BAB ESHTAR SUBSTATION
11 kV FEEDER CABLE
MOSUL, IRAQ

SIGIR PA-06-073
OCTOBER 17, 2006

SUBJECT: Report on Project Assessment of the Bab Eshtar Substation 11 Kilo Volt (kV)
Feeder Cable, Mosul, Iraq (Report Number SIGIR-PA-06-073)

Map 1. Bab Eshtar SS 11 kV Feeder Map (Provided by USACE)

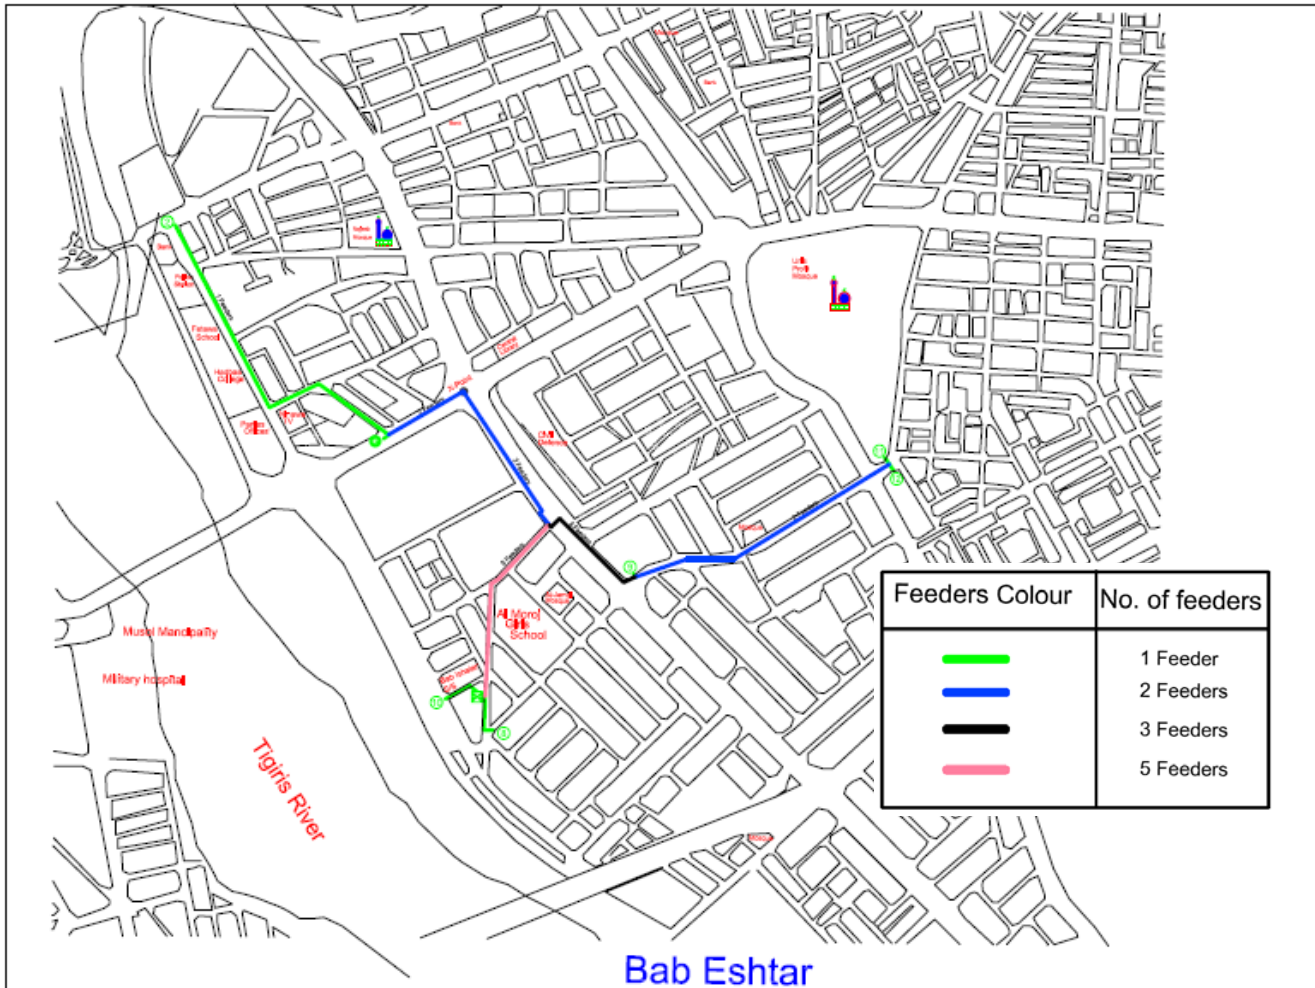
At the time of the site visit, the inspectors found that construction work had progressed to the final trench (trench one) which was dug to an adequate depth according to MOE standards. There appeared to be adequate sand, concrete and backfill layers in accordance with MOE standards.
